**DATA REQUEST RESPONSES
SET 2**

**SOLAR ENERGY GENERATING SYSTEMS (SEGS) VIII AND IX
(88-AFC-01C AND 89-AFC-01C)**

**POST-CERTIFICATION PETITION FOR
BATTERY ENERGY STORAGE SYSTEM**

**SOLAR ENERGY GENERATING SYSTEMS VIII AND IX PETITION FOR
POST CERTIFICATION CHANGE TO ADD A BATTERY ENERGY
STORAGE SYSTEM**

JOB NUMBER	158105	REV	3
SEGS VIII & IX with SEGS BESS		DRAWING NUMBER	
Figure B1: 230kV COMMON SWITCHYARD PLAN		SEGS-BESS-EC-2

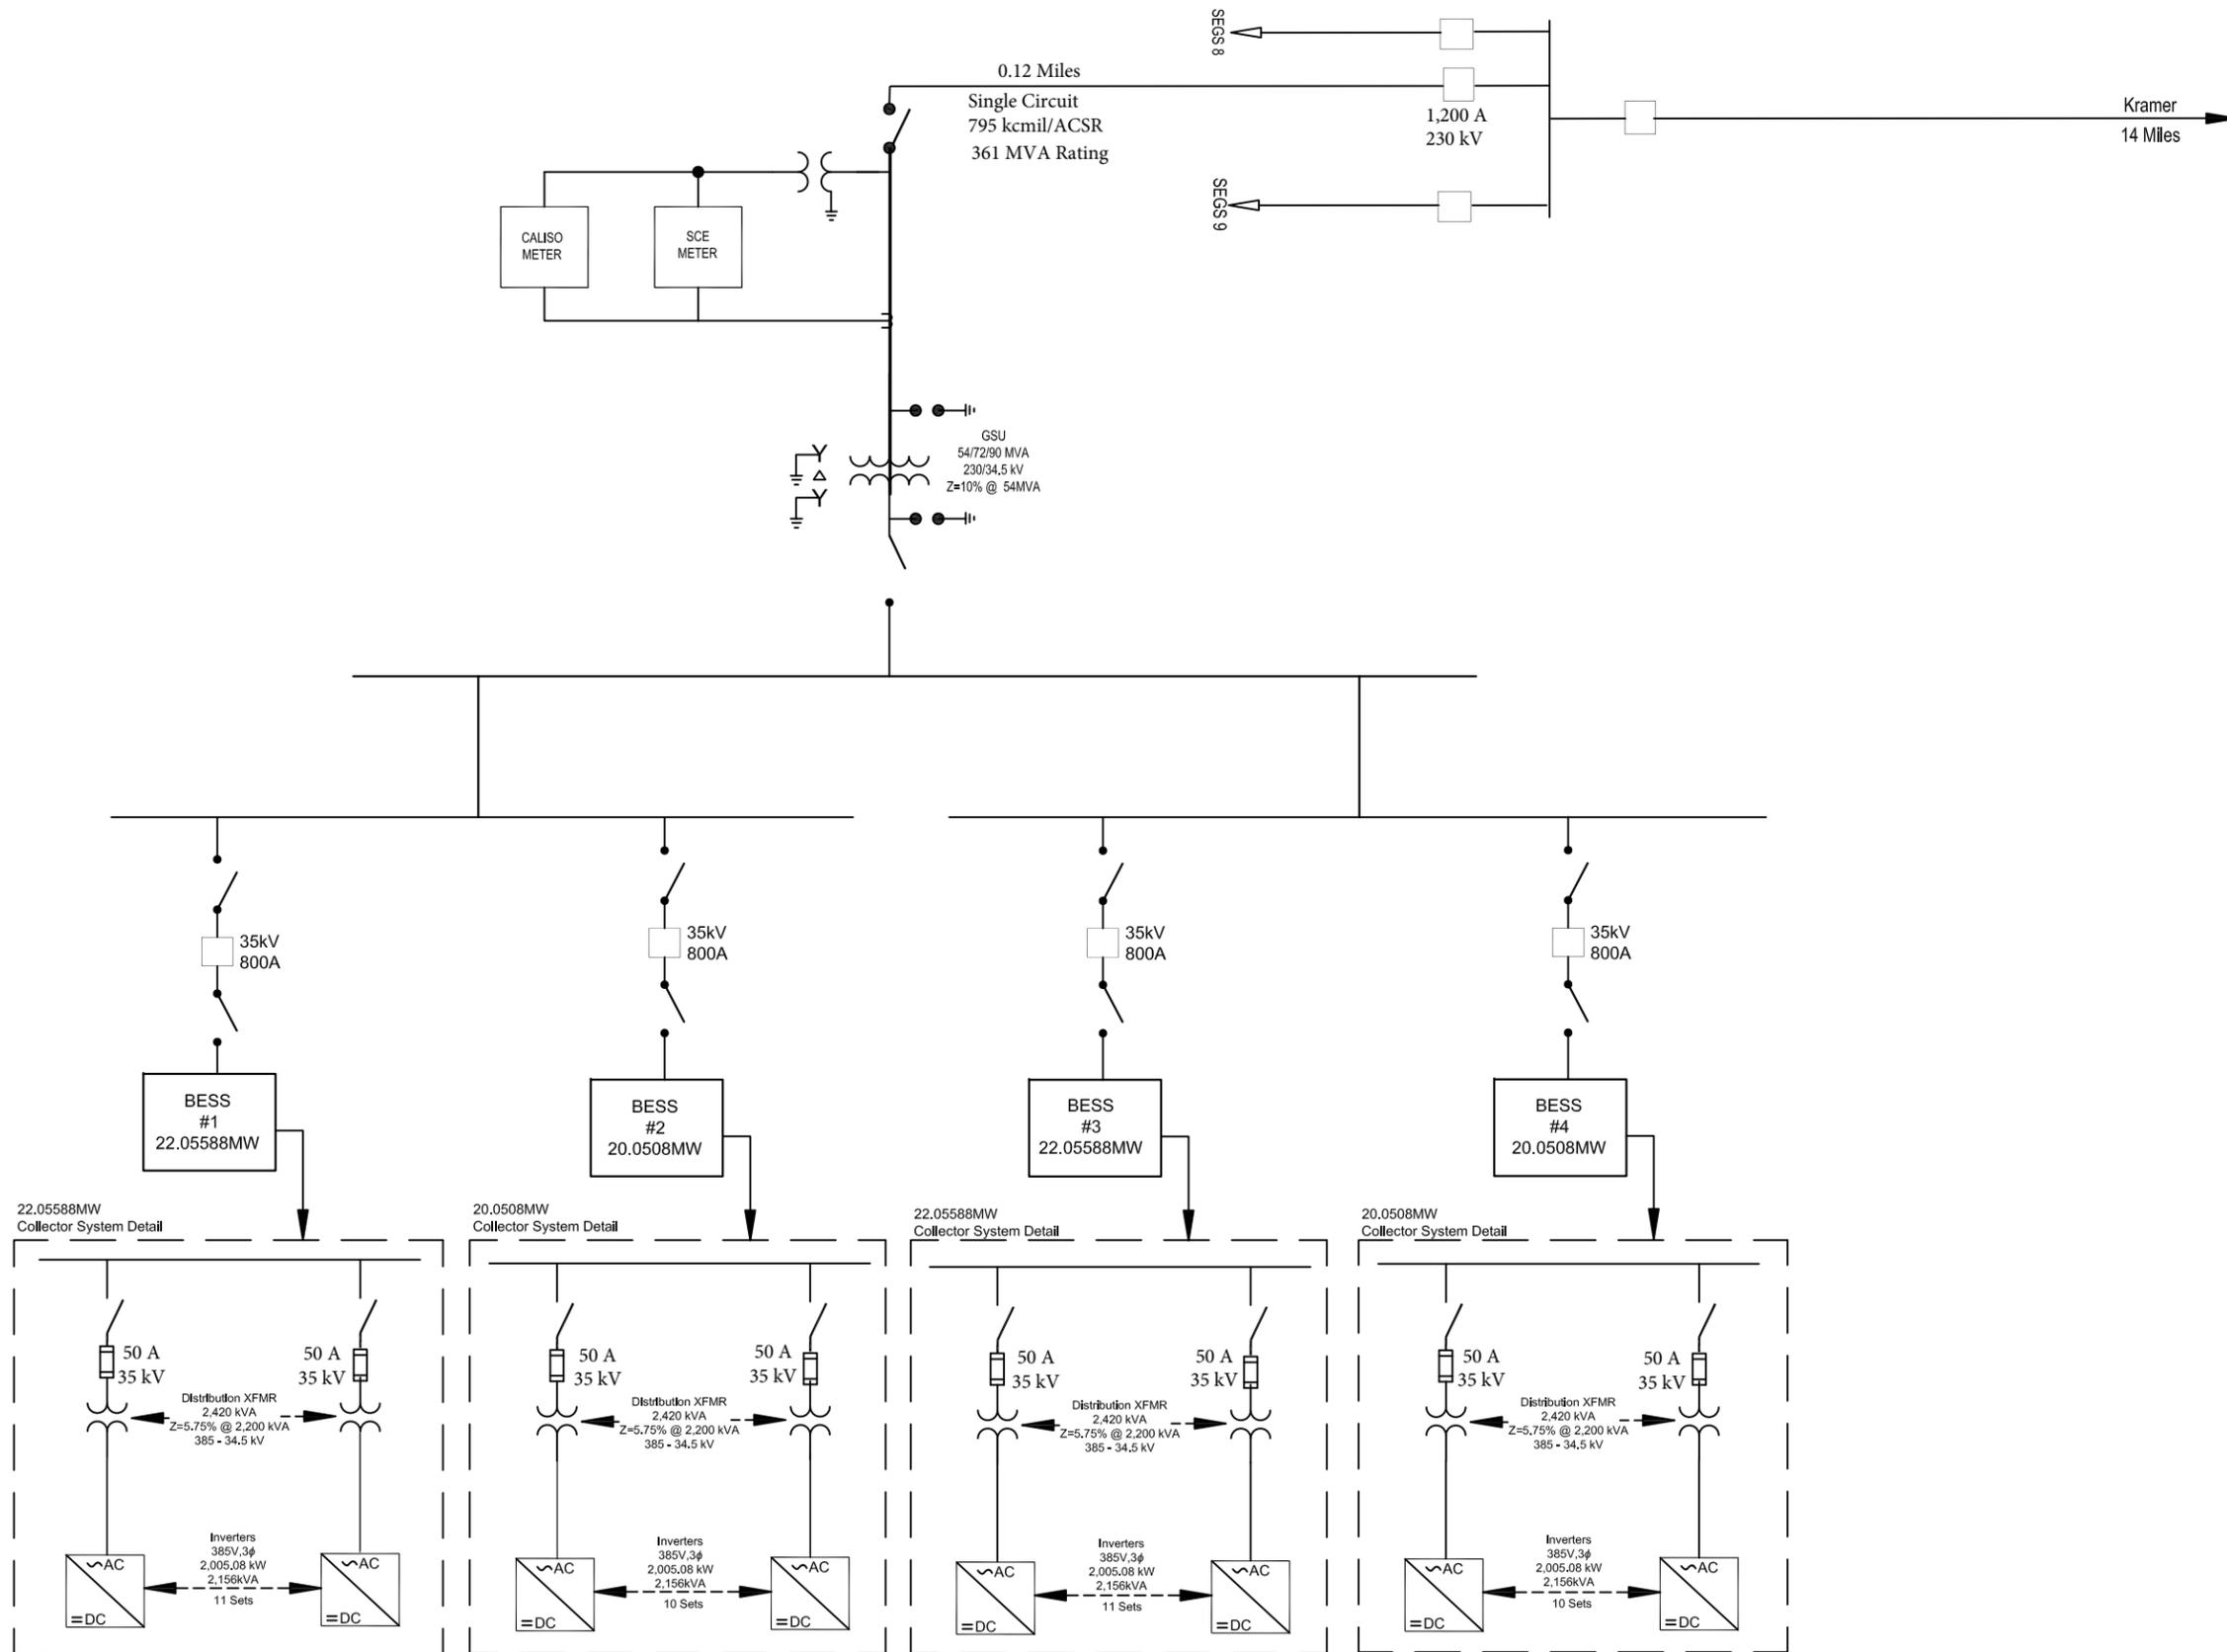
Data Request B1: *Provide a detailed description of any changes in design, construction, and operation of any electric transmission facilities associated with the addition of energy storage and to the existing SEGS VIII and IX facilities. Providing descriptions and drawing of both the existing and proposed facilities would be the most effective way to communicate the proposed changes.*

The BESS system will make use of the existing SEGS VIII and IX switchyard, common 230kV project substation bus, and 230kV generation tie-line all of which currently interconnects SEGS VIII and IX to the 230kV Kramer substation. With the addition of the BESS, the existing on-site switchyard will be modified to add a new breaker, new switches, and new metering.

Please refer to the Figure B1, SEGS VIII and IX 230 kV Common Switchyard Plan, which depicts the existing switchyard and the additions for the BESS system. Since the existing switchyard includes an extra bay position, the overall footprint of the switchyard will not need to be expanded. Please also refer to Figure B2 for the updated one-line diagram included in this response.

TERRA-GEN	JOB NUMBER	REV
	SEGS VIII BESS & SEGS IX BESS		1
	Figure B2: One Line Diagram	DRAWING NUMBER	SEGB-1

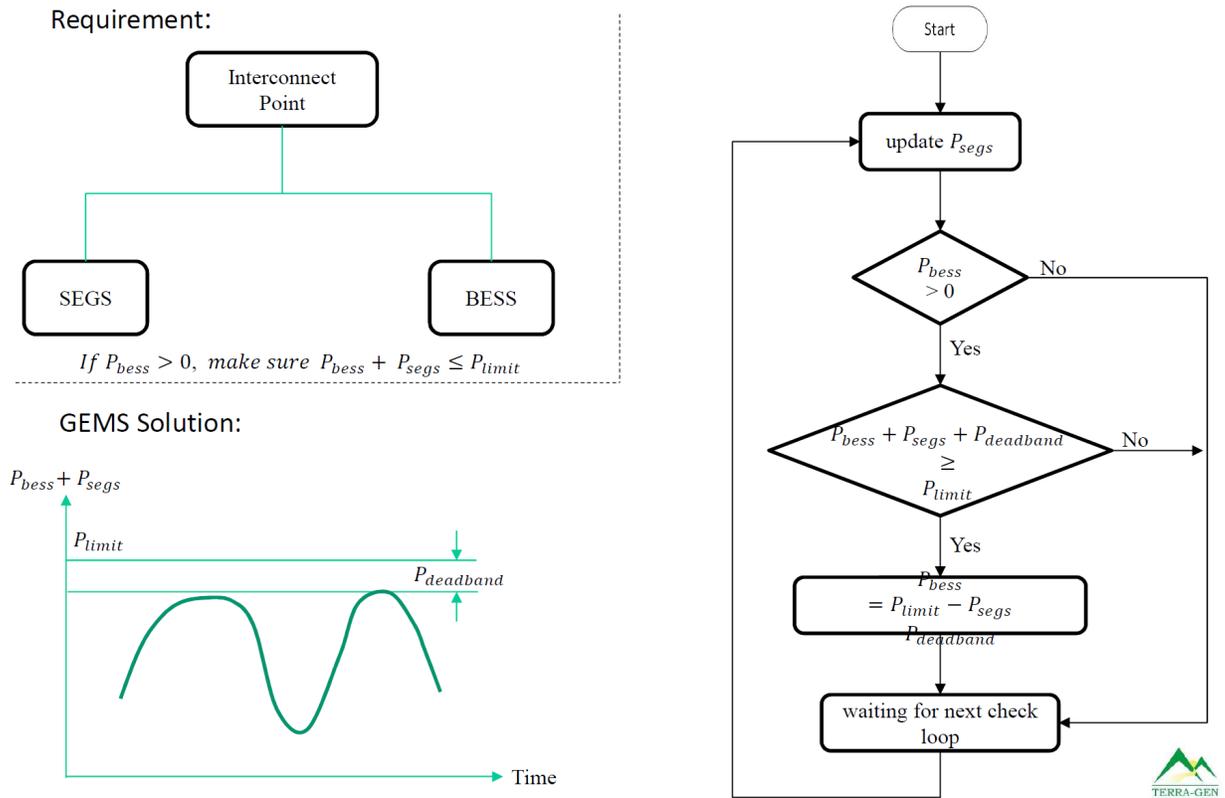
Data Request B7: Please provide a description on the proposed overhead transmission line shown in Figure 3: SEGS Electrical Configuration –Onsite Switchyard View of the Data Request Responses (TN 229725). Please include the type of line, approximate length, and applicable codes and standards.

The new overhead transmission line connecting the BESS to the existing on-site switchyard will be a single circuit 230 kV line approximately 600 feet in length. The line will be designed and constructed to meet the requirements of California General Order 95. Please refer to Figure B2, above, which includes an updated one-line diagram with the additional requested details.

Data Request B2: Please describe and provide a schematic diagram of the feedback control schemes that have been proposed to regulate the net output of the SEGS VIII and SEGS IX, after the addition of the Battery Energy Storage System (BESS), so as not to exceed 160 Mega Watt (MW) at the point of interconnection to the California Independent System Operator (California ISO) grid.

A new energy management system will be overlaid across the existing SEGS VIII and IX facility and the BESS to continuously monitor the output of each facility and modulate accordingly to ensure the interconnection limit is not exceeded. A feedback control diagram is provided below in Figure B3.

Figure B4: BESS SYSTEM LAYOUT

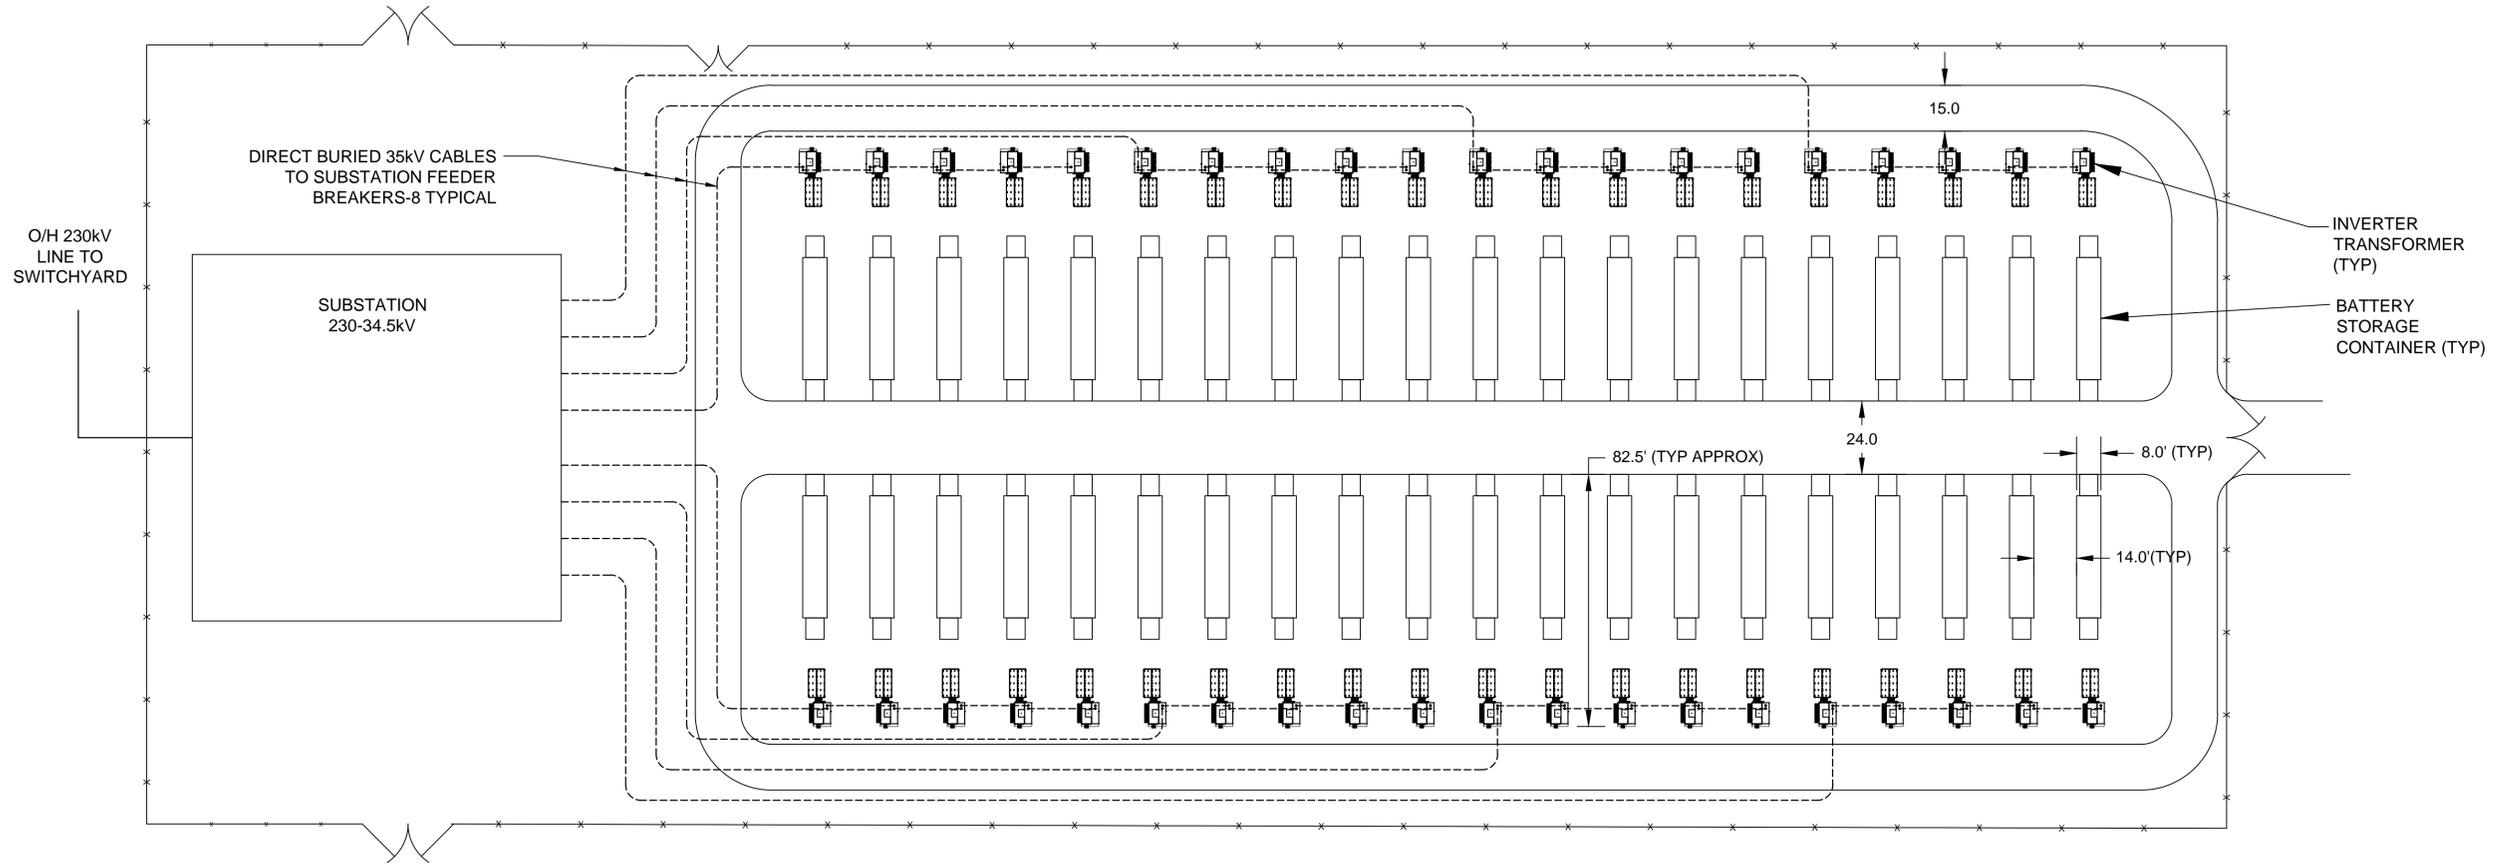
Data Request B8: *Please provide a written description of what the BESS enclosure would be and provide the dimensions of the enclosure and the associated California Building Code occupancies. In addition, please provide a dimensional plan view of the maximum build out for the BESS that would use containers and for the BESS that would use enclosures.*

Based on the latest BESS system design plans, rather than a single building room or enclosure, the proposed BESS system will utilize non-walk-in, outdoor containers, or cabinets that contain the components of the energy storage system such that personnel cannot enter the enclosure other than reaching in to access components for maintenance purposes. Therefore, with this containerized approach, there will be no occupied enclosures.

A typical layout is provided in Figure B4, SEGS VIII and IX BESS System Layout. Container dimensions may vary depending on the BESS System manufacturer selected.
